What we heard from Calgarians

Draft Recommended Plan North Section: 24 Ave. N.W. Area

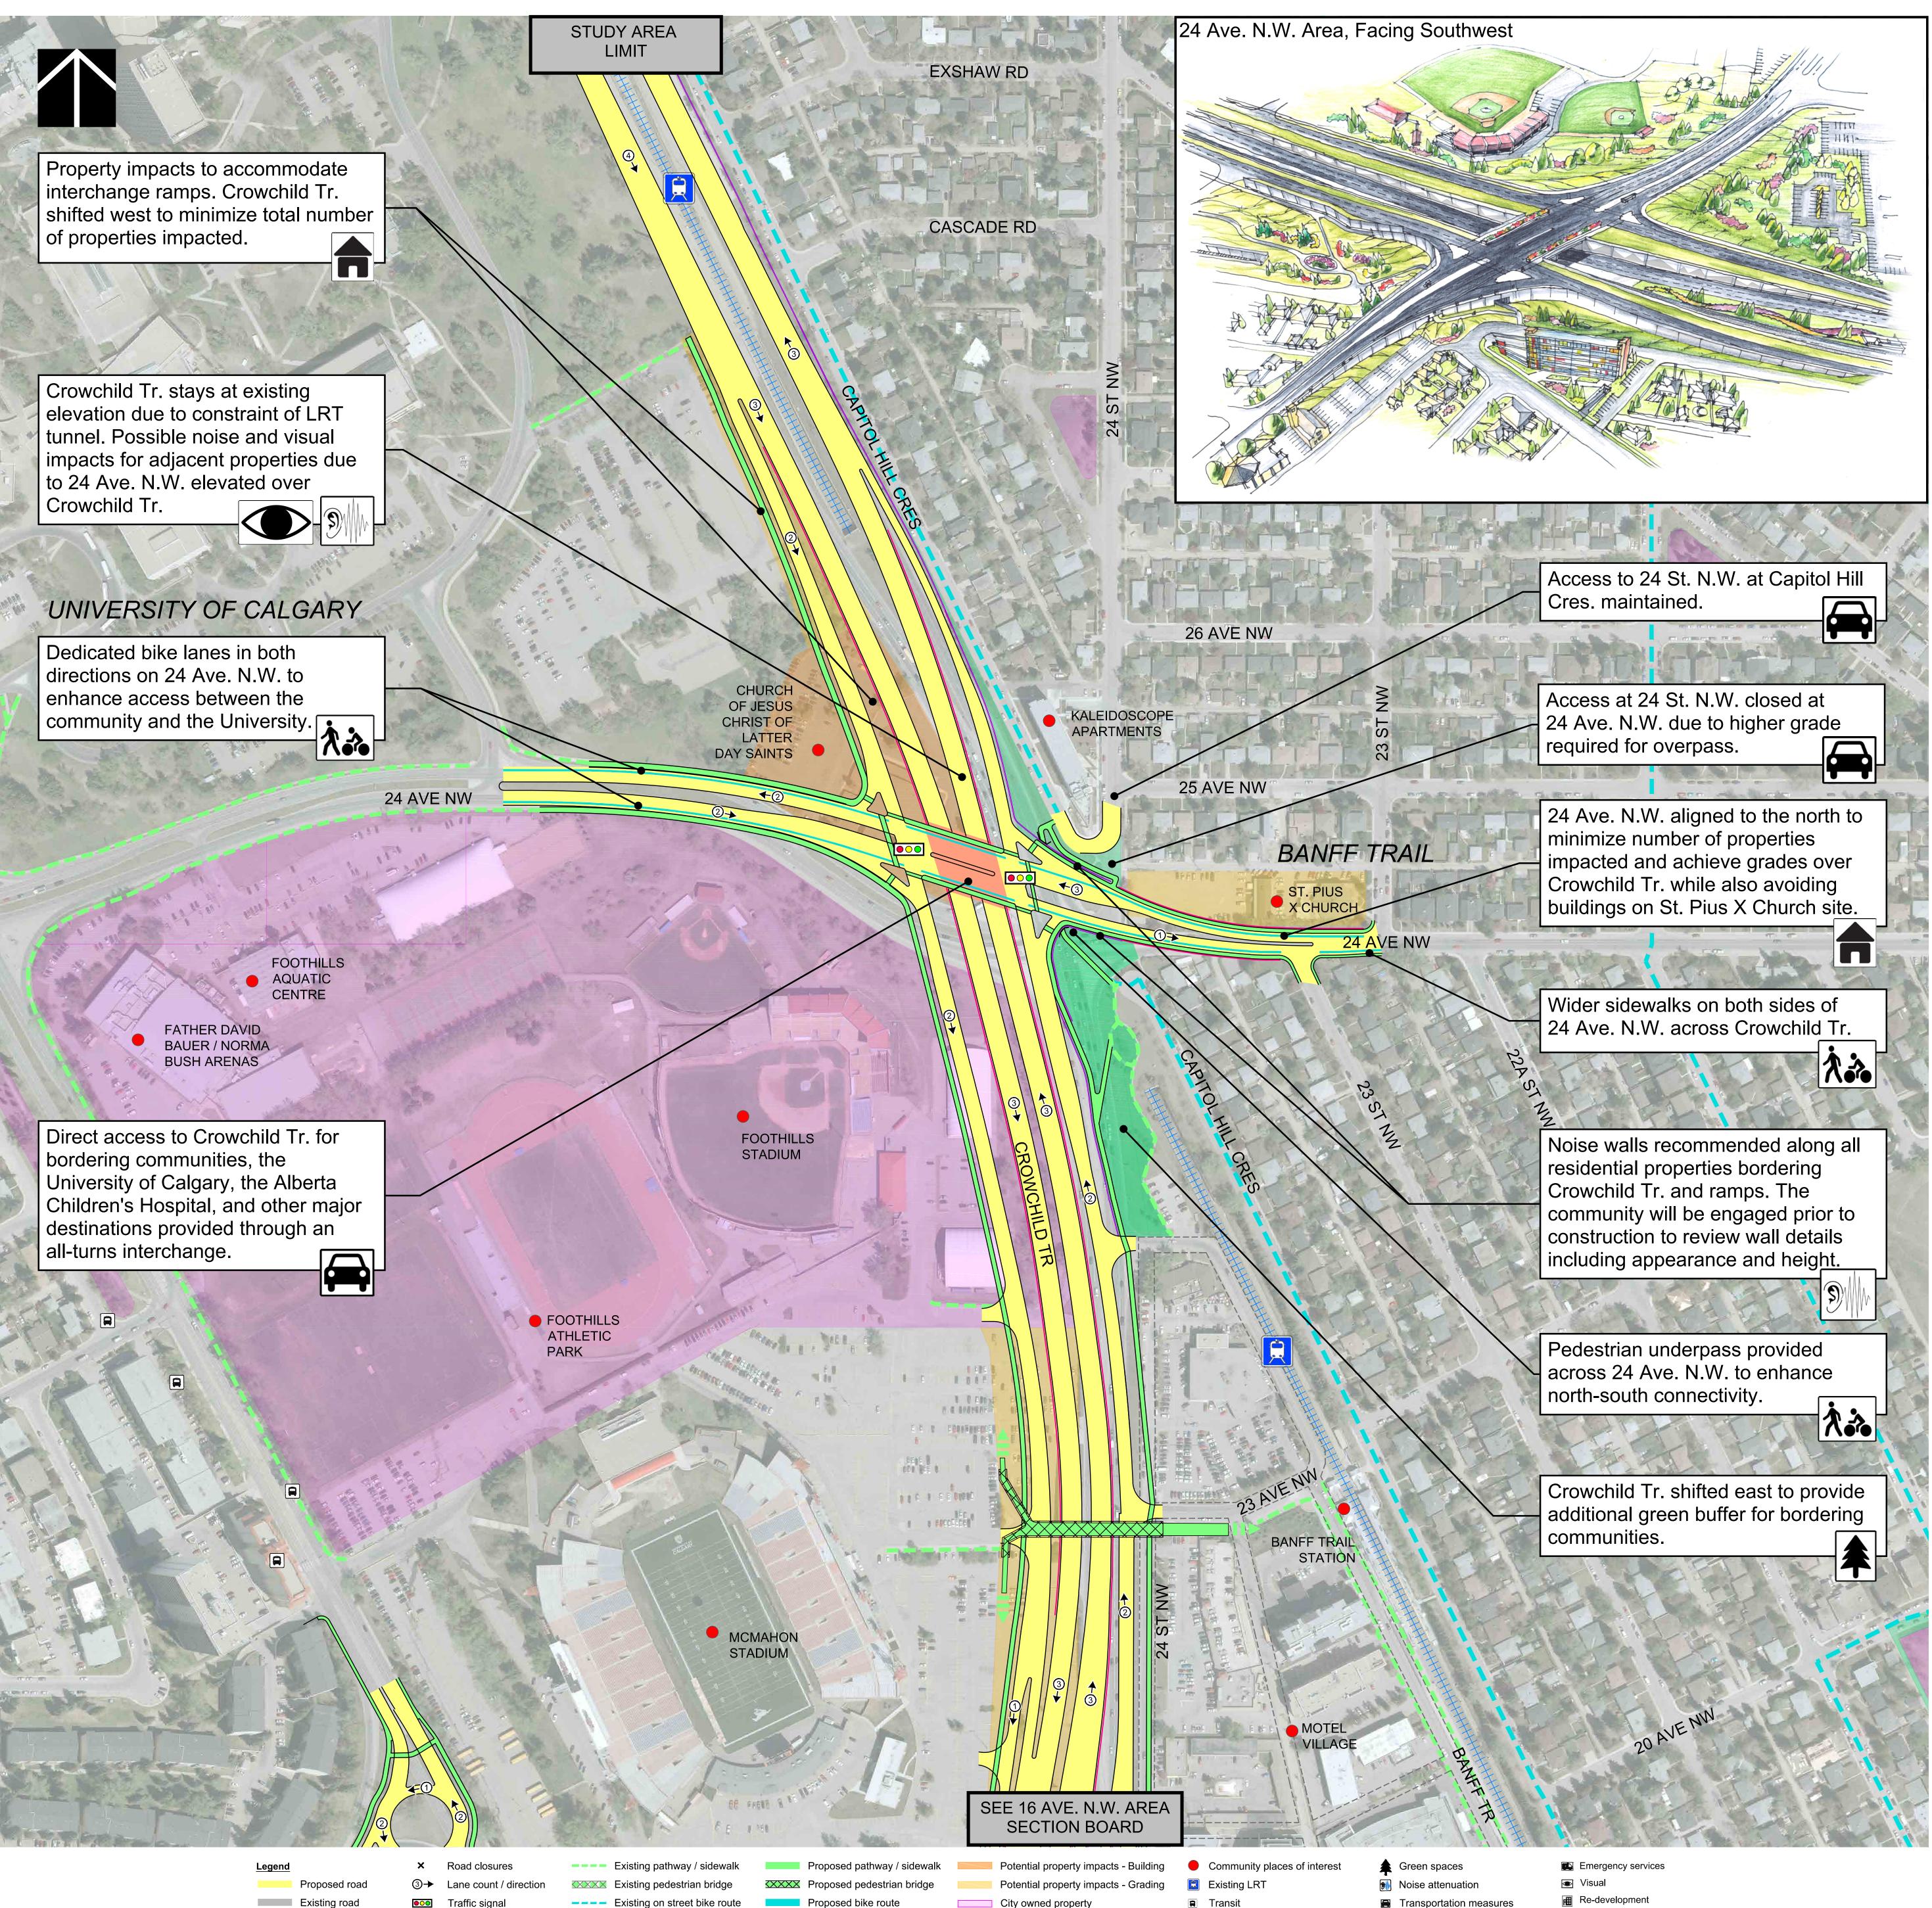
Properties will have to be acquired to accommodate the interchange ramps.

Concerns that elevated ramps would increase noise impacts.

Concerns that the elevated ramps would create negative visual impacts for bordering communities.

Connections along 24 Ave. N.W. and across Crowchild Tr. are important for people who walk and bike.

Concerns that interchange at 24 Ave N.W. will increase traffic volumes on 24 Ave. N.W.

Shifted 24 Ave. N.W. and adjusted the pathway connection to Capitol Hill Cres. to reduce potential impact to St. Pius X site, avoiding existing buildings.

Reduced the size and length of the right-turn bays.

Identified noise walls locations on the plan.

At the time of implementation, noise wall design will be integrated with the surrounding area to reduce visual impact.

Added a pedestrian underpass on the east side of Crowchild Tr. below 24 Ave. N.W. On-street bike lanes provided on 24 Ave. N.W.

The interchange at 24 Ave. N.W. works together with upgrades to 16 Ave. N.W. to balance and distribute traffic demand on the area road network, while maintaining access to bordering communities.
